LilyPad - PowerSupply

TITLE: LilyPad_PowerSupply-v18

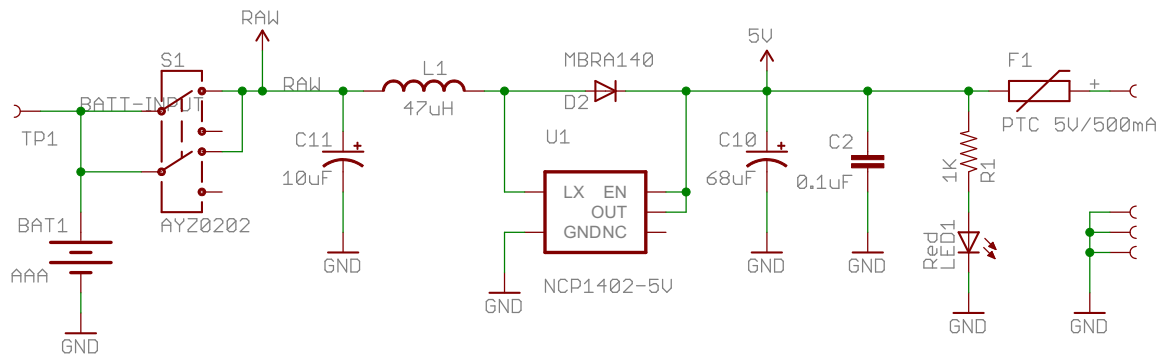
- v18 Fixes:
- * U1 changed from NCP1400 to NCP1402
 - * C10 changed from 47uF to 68uF
 - * L1 changed from 22uH to 47uH
 - * No changes to PCB design
